Product Change Notification

Product Group: OPT/Tuesday September 1, 2026/PCN-OPT-1496-2026-REV-0

VO42xx, VO305x OptoTRIACs green production line transfer

PCN OPT-1496-2026 Package Dimensions Comparison

DIP-6

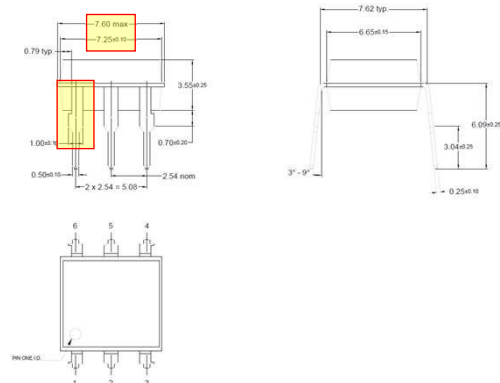
Note: major changes are the package length and the lead shape form

DIP-6, 400 mil (option 6)

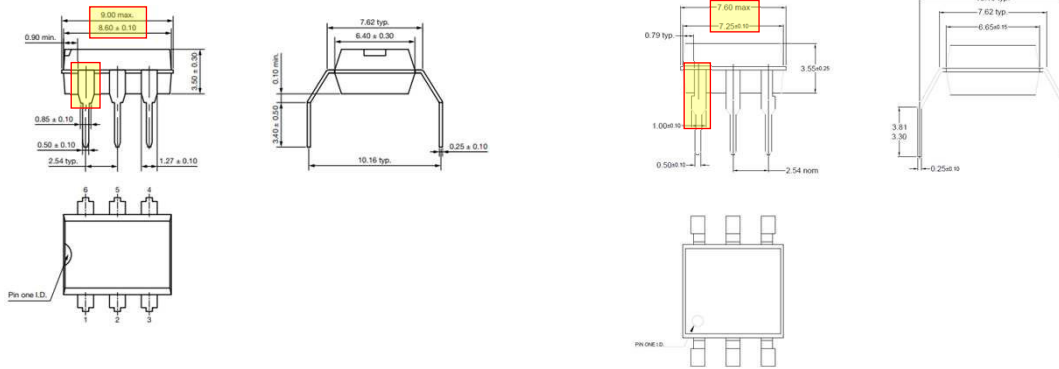
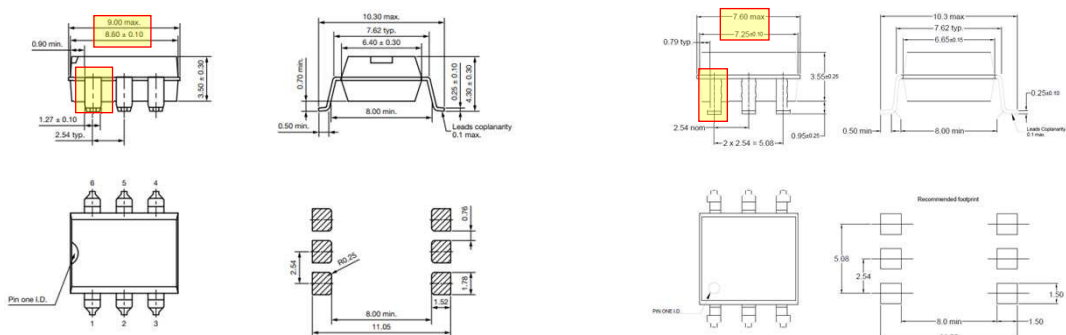
Note: major changes are the package length and the lead shape form

SMD-6 (option 7)

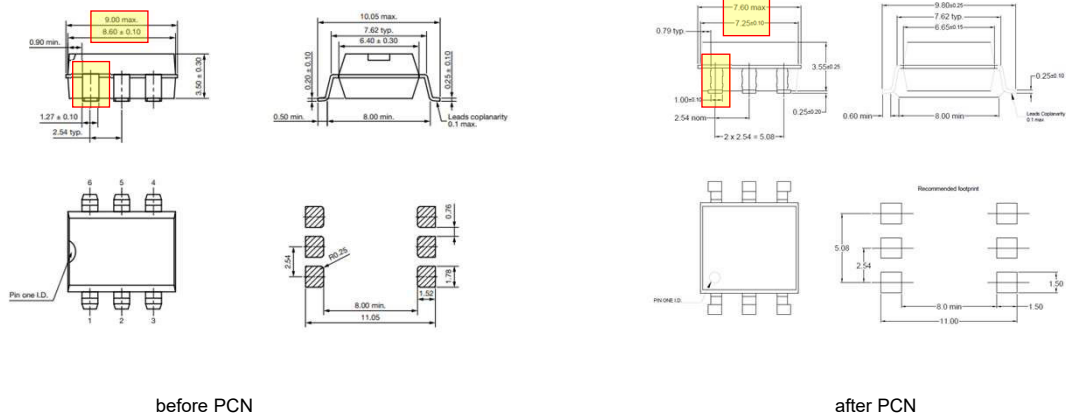
Note: major changes are the package length and the lead shape form
